**Comments of North America Transmission on  
Draft Western New York Public Policy Transmission Planning Report**

July 24, 2017

Attachment B  
Wood H-Frame Horizontal and Steel Monopole Delta Unit Cost Comparison

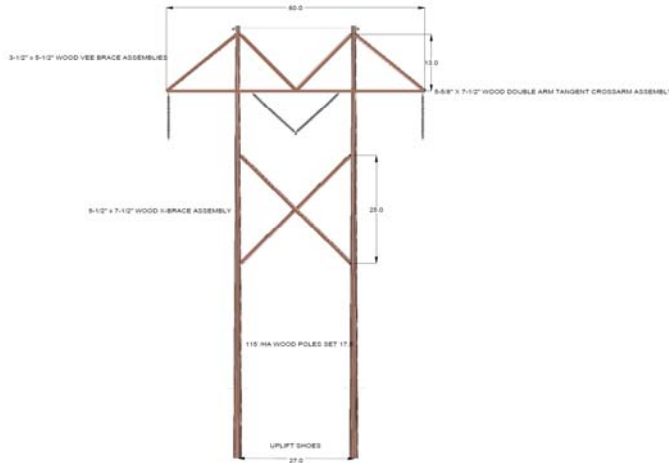
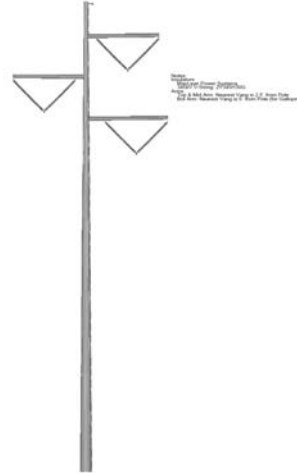
The cost estimates for the Tier 1 proposals do not appear consistently developed and mistakenly favor construction of structures using wood versus steel. Proposals T014/T015 are based on a wood H-frame structure configuration whereas every other proposal is based on steel monopole. The cost difference assumed by SECO between wood and steel is evidenced by a comparison of the transmission line foundation and structure costs for Proposal T014/T015 (wood) versus Proposal T014/T015 Alternative (steel).

As shown in *Table 1*, SECO estimates wood pole construction to cost nearly \$1 million less *per mile* than steel pole construction. This is clearly incorrect.

NAT and its affiliates have conducted several recent structure selection studies which included quotes from suppliers, including for New York projects, and concluded the initial capital cost for a wood H-frame transmission line to be comparable to steel. An example of a comparison calculation is included as Attachment B, which shows that wood pole construction may save up to \$5,600 per structure, or \$750,000 total for 133 structures. Note that this comparison is conservative in that it does not account for the wider right-of-way, additional clearing, or additional cost of 3 pole steel dead-ends required for the wood H-frame scenario, relative to single pole steel deadends for a steel monopole tangent.

If this is the origin of the difference in cost for the transmission line work among Proposal T014/T015 and Proposal T006, we request that SECO re-examine its estimates for this work. SECO may have an unreasonably high estimate for the cost of steel, which appears nearly twice the well supported estimate included in NAT's proposal. SECO's estimated value of ~ \$12 million for "Structures-Transmission Line" is over \$3 per pound<sup>2</sup> (pre-markup and contingency). An affiliate of NAT recently received binding proposals for steel monopoles for an approximately 70 mile 345 kV transmission line in the range of \$1.20 to \$1.40 per pound - less than half the amount assumed in the SECO estimate. This single incorrect assumption accounts for approximately \$8 million of the cost difference between Proposal T006 and Proposal T014/T015.
